MCP98242 Rev. A1 Silicon Errata

The MCP98242 family devices that you have received conform functionally to the current Device Data Sheet (DS21996B), except for the anomalies described in this document.

The following typographic corrections and clarifications are to be noted for the latest version of the device data sheet (DS21996B):

FIGURE 1: Flow Chart.

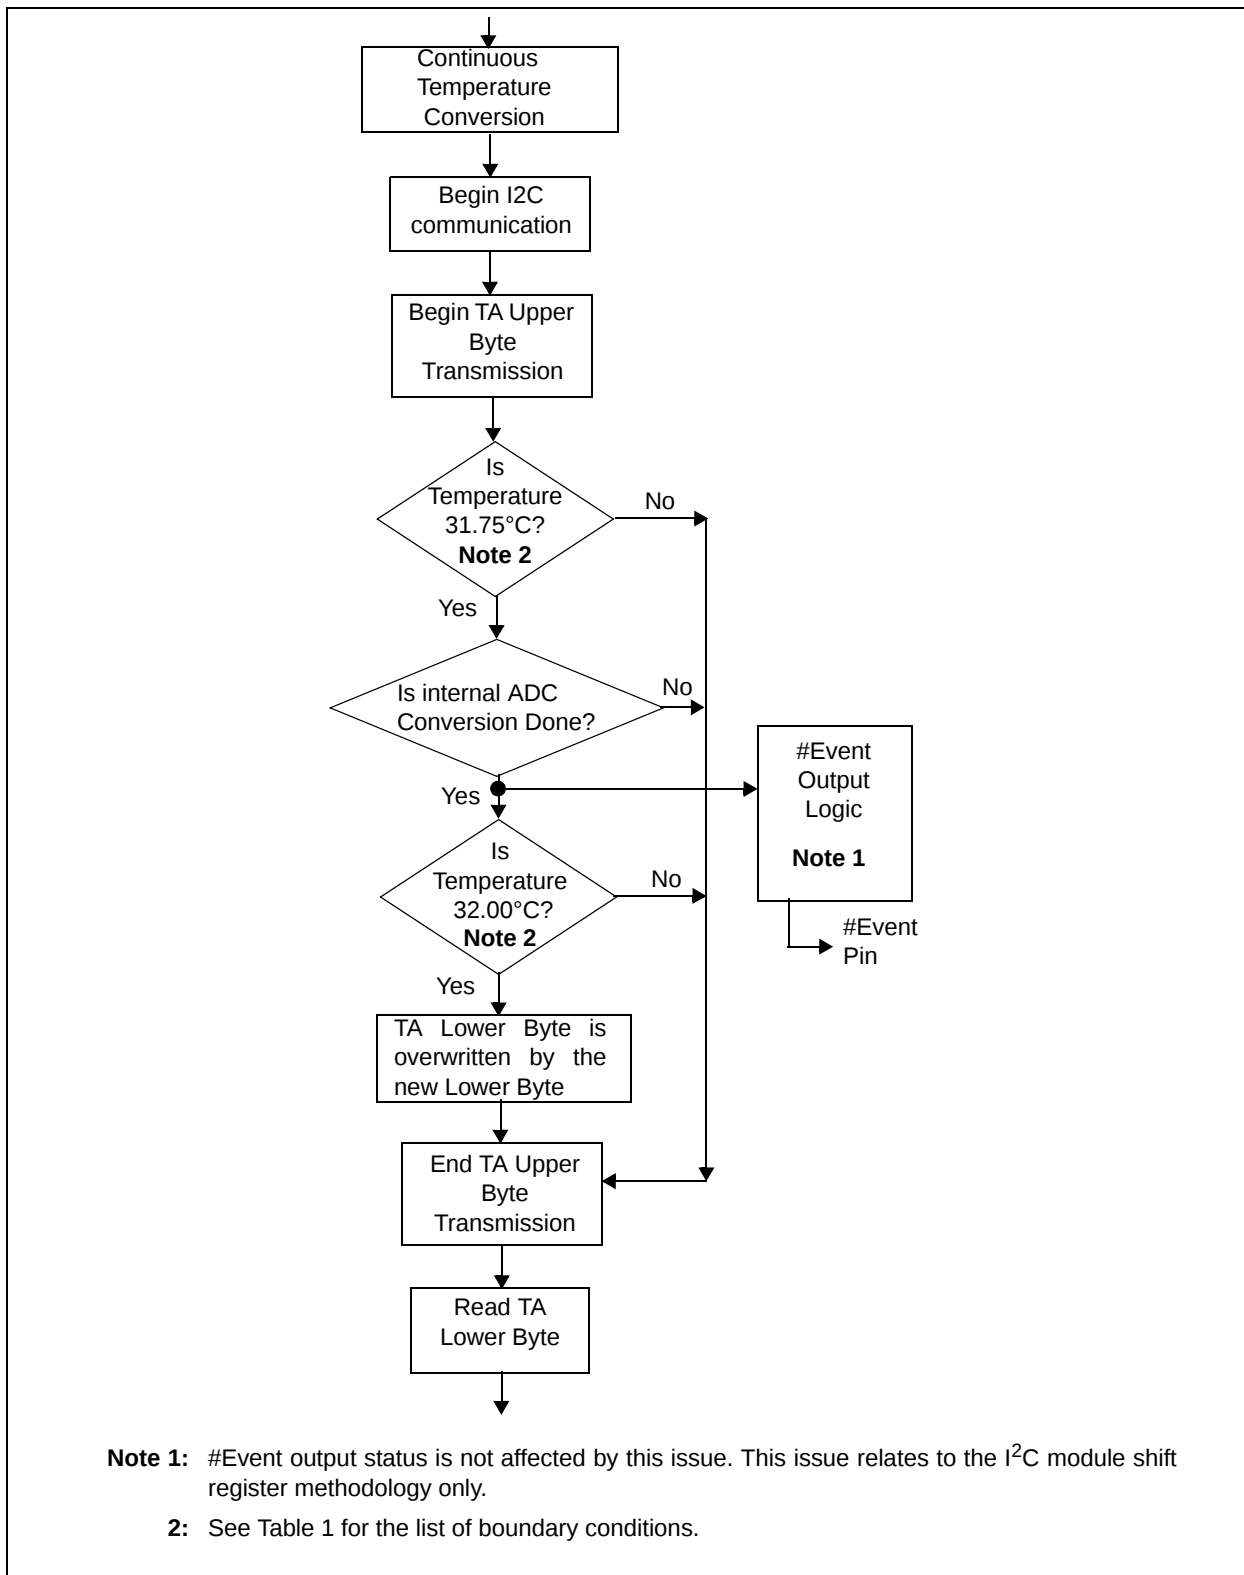
Byte 1 must be in $I^2\text{C}$ transmission for this issue to occur and the ADC must complete conversion while $I^2\text{C}$ is in communication. In addition, the ambient temperature must be at multiples of $16^\circ\text{C} \pm 0.25^\circ\text{C}$ for the temperature register to be partially overwritten.

Figure 1 shows flow diagram describing the specific conditions for the synchronization issue occurs. Table 1 shows a complete list of temperatures greater than 0°C.

For temperature conditions other than Table 1, the device blocks data overwrite. Therefore, this issue will not occur.

If the ambient temperature read is within the host temperature limit, then do nothing. Otherwise, if the new temperature read is greater than or less than the previous temperature data by exactly 16.00°C, then perform a Repeat Read to receive the correct temperature data. There is a 0% probability that the Repeat Read data would be corrupted, if the Repeat Read is performed within T_{CONV} (65 ms). If a Repeat Read is performed after 65 ms then there is a greater than 0% probability that the next conversion would also be corrupt by ±16.00°C as stated in Table 1. In this case, disregard this reading and perform a Repeat Read and compare the result with the last known good reading.
